R44 SERVICE LETTER SL-41

DATE: 07 September 2011

SUBJECT: Ground Handling Wheels and Wheel Supports

FIGURE 1

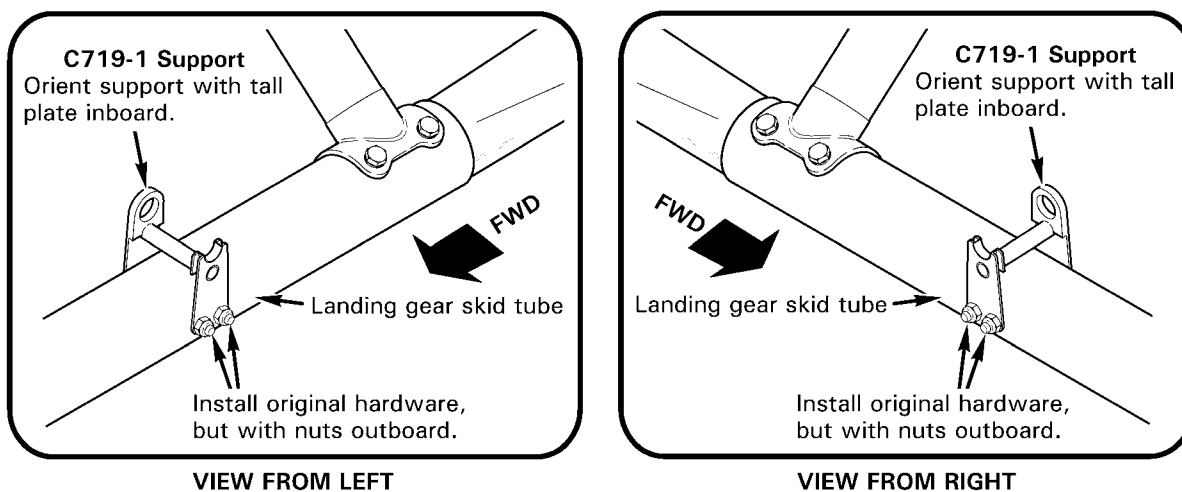
BACKGROUND: C063-1 ground handling wheels are no longer available from the factory. Wheel supports on production helicopters are oriented for C063-5 (LH) and C063-6 (RH) ground handling wheels, installed inboard of landing gear skid tubes. New wheels may be used on earlier R44 helicopters when the wheel supports are rotated 180°. Earlier wheels may be modified for inboard installation.

1. Refer to R44 Illustrated Parts Catalog (IPC) Figure 3-1. Remove hardware securing C719-1 support to landing gear skid tube and remove support. Thoroughly clean and visually inspect support, and skid tube at support attachment.
2. Refer to Figure 1. Orient support with tall plate inboard and install original hardware, but with bolt heads inboard for tire clearance. Special torque nuts to 70 in.-lb and torque stripe per R44 Maintenance Manual (MM) Figure 2-1. Repeat steps for opposite support.

FIGURE 2

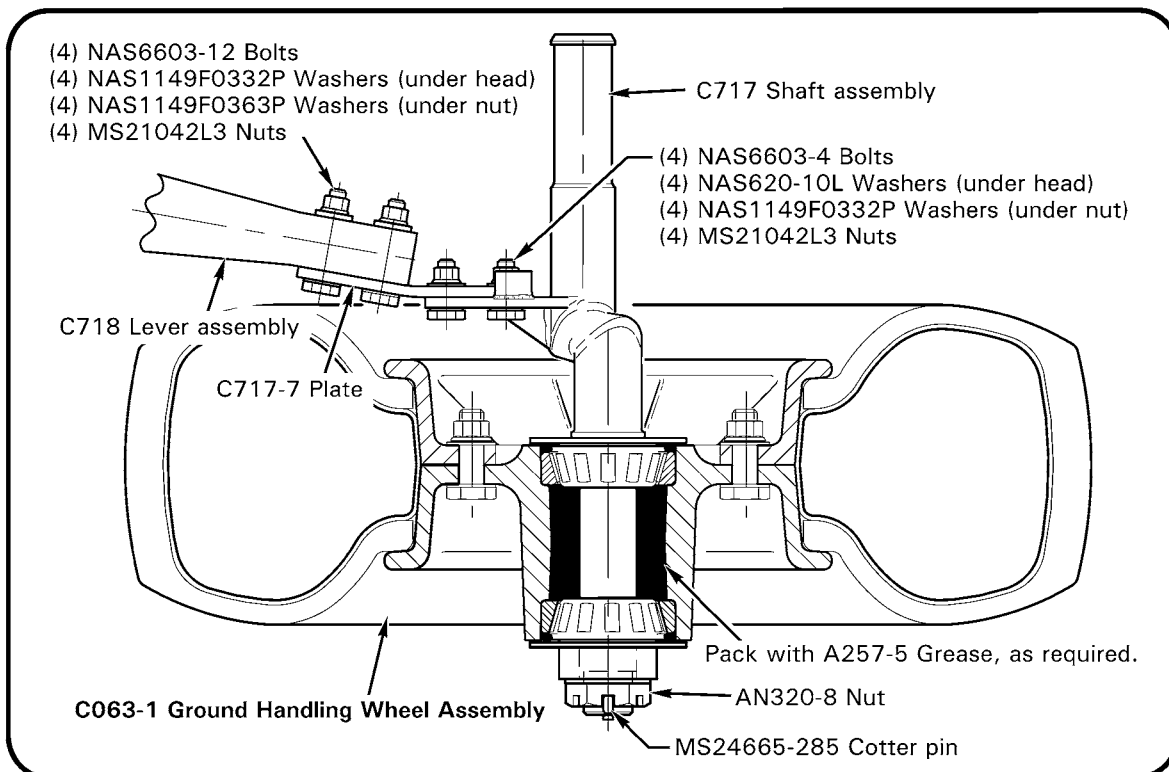
1. Order KI-210 kit from RHC Customer Service.
2. Refer to IPC Figure 3-7. Remove cotter pin and nut securing C717 shaft assembly to wheel. Pull shaft assembly, with attached C718 lever assembly, from wheel.
3. Remove hardware securing lever to shaft.
4. Refer to Figure 2. Install hardware securing C717-7 plate to lever and shaft. Special torque nuts to 70 in.-lb and torque stripe per MM Figure 2-1.
5. As required, pack wheel cavity and bearings with new A257-5 grease. Insert shaft assembly in wheel and install nut. Special torque nut to 30 in.-lb, then loosen nut to nearest castellation, and install cotter pin. Repeat steps for opposite wheel.

\$90.30 for KI-210, to modify earlier ground handling wheels. KI-210 includes C717-7 plates, MS24665-285 cotter pins, NAS6603-4 bolts, NAS6603-12 bolts, NAS620-10L washers, NAS1149F0332P washers, NAS1149F0363P washers, and MS21042L3 nuts.
